Town of Knightdale

Staff Report

Title: Lyndon Oaks Planned Unit Development (ZMA-2-23)

Date: July 17, 2024

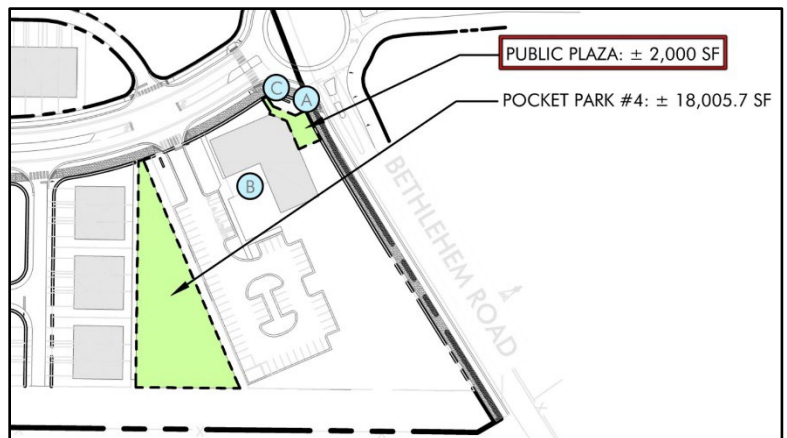
Staff Analysis (April 18, 2024 Master Plan): *One of the purposes of this requirement is to assist with providing more equitable access to neighborhood amenities regardless of the location of one's home. In order to comply with Section 11.2.B.2 of the UDO, the Applicant should continue to explore alternative options for a more centrally located amenity center or evaluate other locations for a second amenity center.*

Applicant Response: *The layout of the proposed development was revised to relocate the amenity center to a central location along the future Widewaters Parkway. (Graphic revised to reflect current proposal)*

April 18, 2024 Proposed Cross-Section

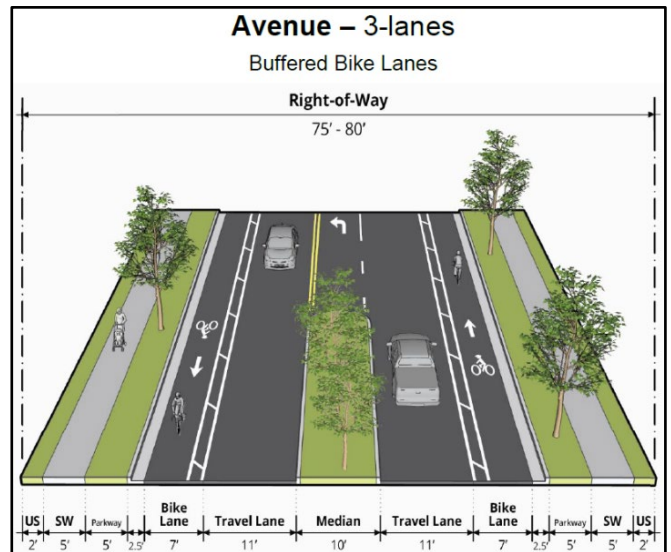
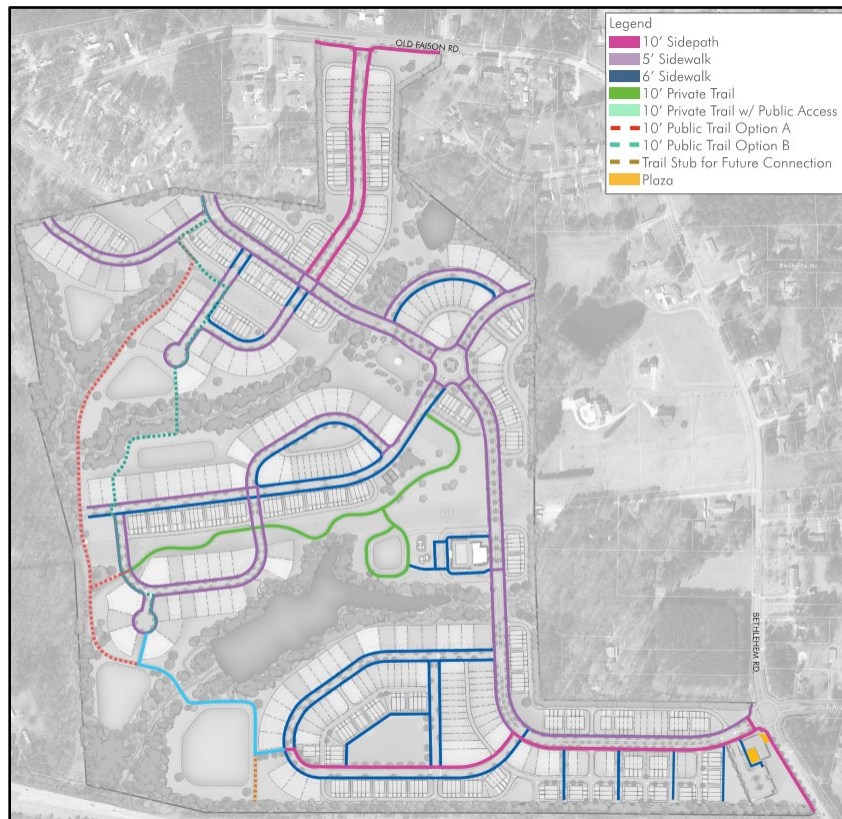
Staff Recommendation (April 18, 2024): Throughout the Master Plan review, staff informed the Applicant that the Comprehensive Transportation Plan (CTP) and UDO do not call for a sidepath along this portion of the Widewaters Parkway Extension, and therefore, the Avenue – Sidepaths Cross-Section should not be constructed. Instead, it is staff’s recommendation to construct the Avenue – Buffered Bike Lane Cross-Section and explore the option of expanding the right-of-way from 75 feet to 80 feet to account for a ten-foot-wide sidepath on one side of the street.

Applicant Response: The proposed roadway cross-section for Widewaters Parkway and site design has been modified to comply with the CTP, UDO, and staff recommendations.

Staff Analysis: The Avenue – Buffered Bike Lane Cross-Section is the appropriate roadway cross-section to build based on previous analyses conducted through the Town’s Comprehensive Transportation Plan (CTP).

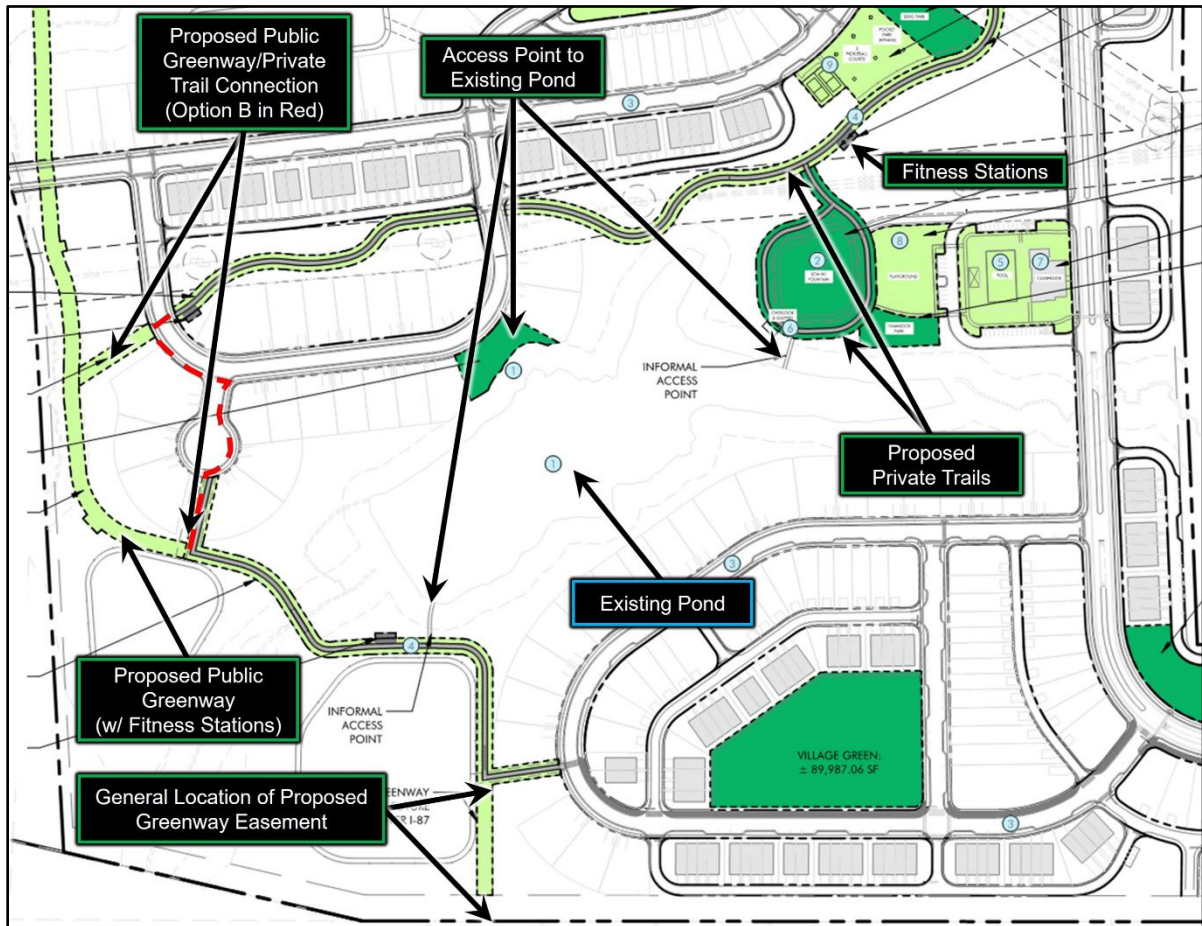
Staff Analysis (April 18, 2024): To increase pedestrian connectivity throughout the site, staff encourages the Applicant to continue to explore the feasibility of connecting the private trail network to the public trail network through the powerline easement that runs east to west along the middle of the site. Staff also encourages the Applicant to continue to explore the feasibility of adding a trail around the existing pond towards the south-central portion of the site. Below graphic updated to reflect current proposal, which addresses staff comments.

Applicant Response: The private trail network has been revised to extend through the powerline easement and connect to the proposed public greenway trail in the general location shown on the above graphic. The revised Master Plan also provides an Option B route (similar to the requested optionality for the public greenway corridor described on Page 17 of this Staff Report) for this private/public trail connection for consideration in case the environmental permitting through the United States Army Corps of Engineers (USACE) is not achievable based upon the developer's cumulative stream and wetland impacts across the entire site. A formal paved trail around the existing pond presents challenges in terms of environmental impacts and potential negative effects to the existing pond's stability. In lieu of a formal paved trail, the Applicant revised the Master Plan to include a passive open space area near the northwest portion of the pond so residents can still access the pond and enjoy its natural beauty (see above graphic).

Staff Analysis: The revised private trail network increases pedestrian connectivity through the site and allows residents to join the public greenway trail via a more natural setting rather than using a roadside sidewalk. Staff support this public/private trail connection as it has been proposed to implement the recently adopted Transportation related Zoning Text Amendment (ZTA-1-24). Staff also support the request for optionality but will continue to encourage the Applicant to prioritize the construction of Option A for both the public and private trail networks. In terms of the paved trail around the existing pond, the Applicant indicated that additional informal access points can be provided at select areas (in addition to the passive open space area to the northwest) so residents can still embrace the natural beauty of the pond in the absence of a formal, paved trail. Staff support these informal access points because it is an opportunity to balance environmental protection (selective clearing per USACE regulations) with amenitizing an existing natural feature for the benefit of the community. Staff recommend these informal access points are identified on the Master Plan. **These informal access points have been identified.**

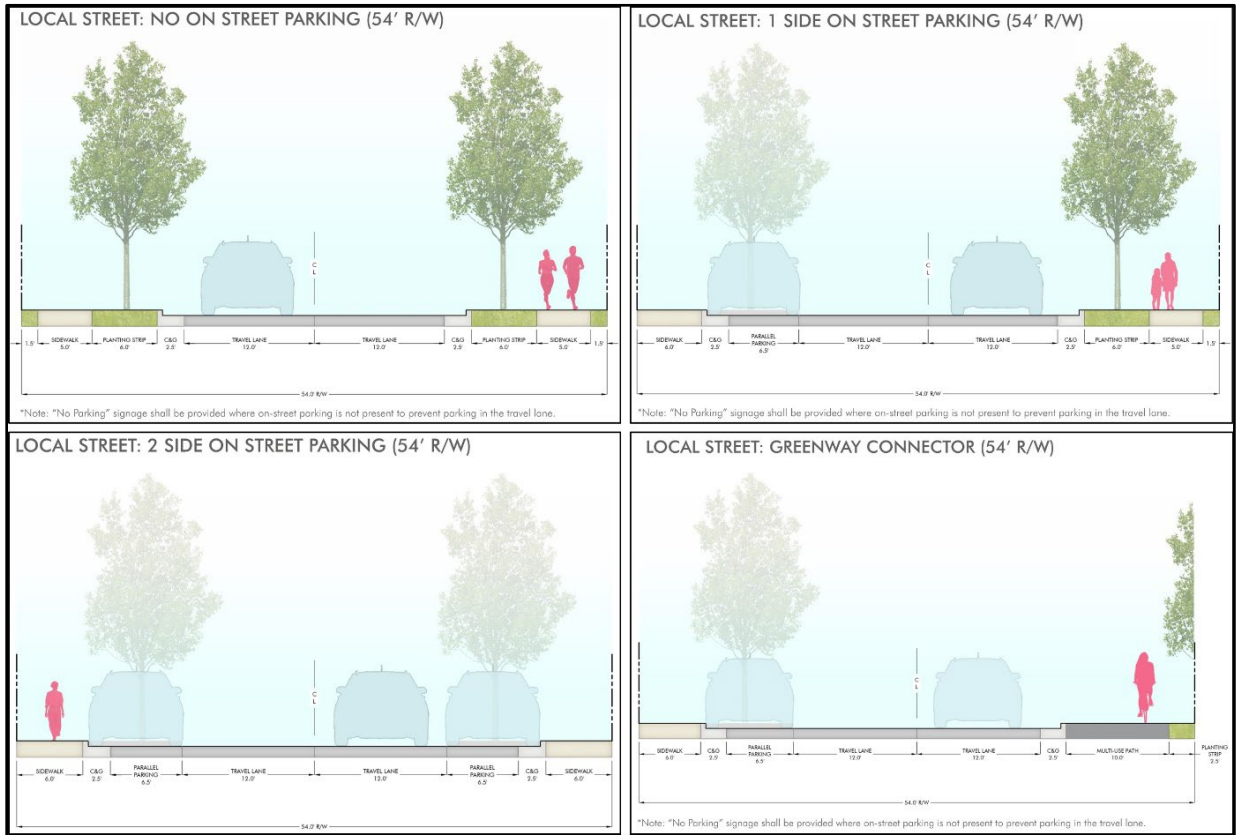
Staff recommend the Local Street Section – Greenway Connector cross-section is either expanded to a 60-foot-wide Public Right-of-Way so that all improvements are located within a single right-of-way (removing the need for a separate easement), or the multi-use path is shifted to be adjacent the curb & gutter, and the street trees are planted on private property (right-of-way width remains 54-foot-wide).

Applicant Response: The Local Street Section – Greenway Connector cross-section was revised based upon Staff recommendation.

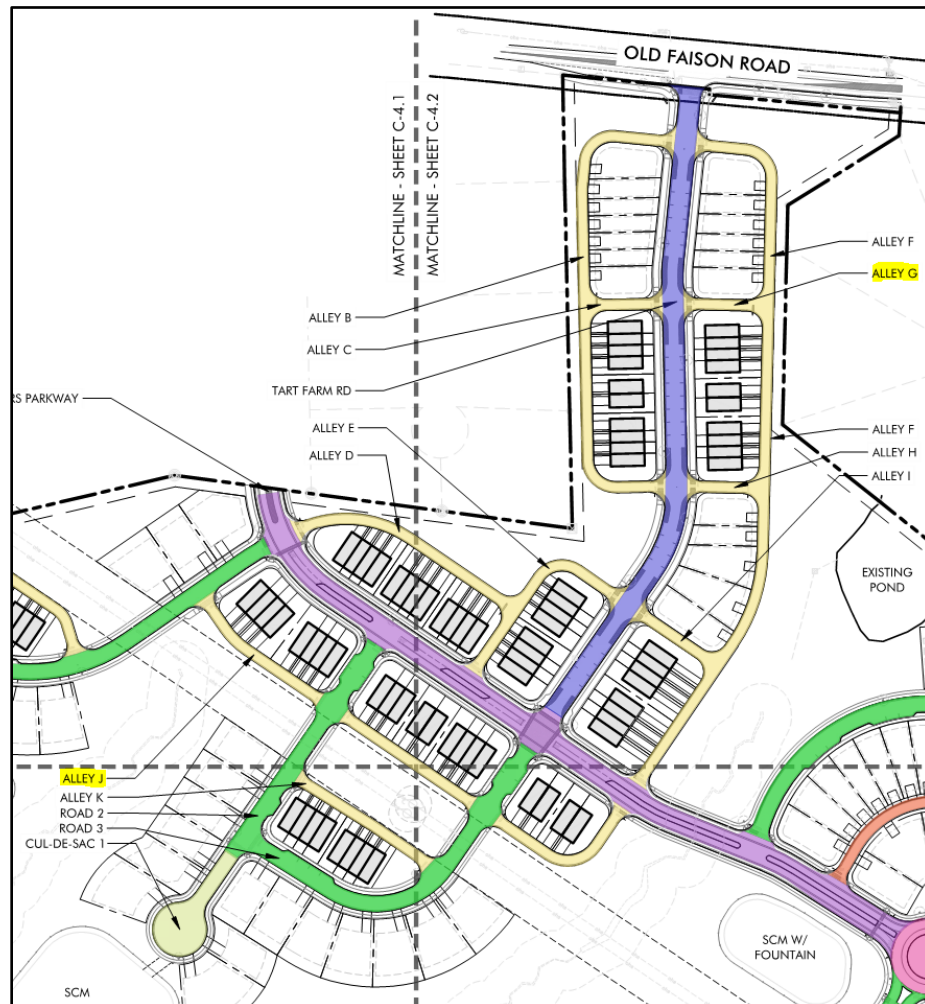
Staff Analysis (April 18, 2024): When a rear-loaded residential lot is served by an alley but is not adjacent to a public right-of-way (i.e. when open spaces separate the lot and right-of-way), modifications to the dedication type (private vs. public) and width are necessary to accommodate the installation of water and sewer infrastructure. Staff concurs that Alleys I, J, K, O, R, V, W, and X warrant a public alley designation due to the presence of open spaces between the residential lot and right-of-way. However, the homes along Alley G front the future public Widewaters Parkway Extension, where water and sewer infrastructure could be installed.

Applicant Response: The dedication of Alley G has been revised to be a private alley. This alley has been renamed to Alley J on the revised Master Plan due to additional alleys being added along the main access road to Old Faison Road.

Staff Analysis: Staff support the proposed change from a public alley to a private alley because it still allows for water and sewer infrastructure to be installed within the Widewaters Parkway Extension, without the need for expanding the right-of-way to 32-feet.

April 18, 2024 Proposed Design

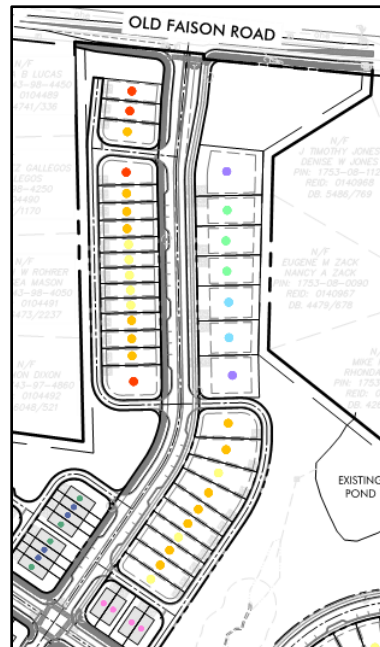
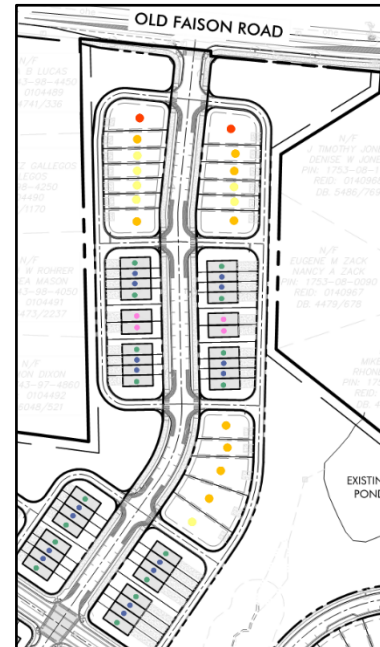
- **Requested:** The Applicant proposes a modified Main Street Cross-Section for the development's access drive (currently known as Tart Farm Road). The proposed design of this road meets the standards outlined in Section 7.2.A.2 of the UDO, except for the landscaped median. The Applicant proposes to remove this required median so that driveway and alley access are not restricted.

Applicant Response: *The design of this portion of the neighborhood has been revised to propose rear-loaded housing products rather than front- and rear-loaded housing products. The roadway design has also been revised to implement the Urban Main Street – Wide Sidewalk Cross-Section.*

Staff Analysis: Staff support the proposed revisions to this roadway as they eliminate several driveway curb cuts along a main entrance to the neighborhood that could have created unsafe conditions. In addition, the change to all rear-loaded housing products and roadway design present an opportunity to provide a high-quality streetscape with landscaping, hardscaping, and fencing.
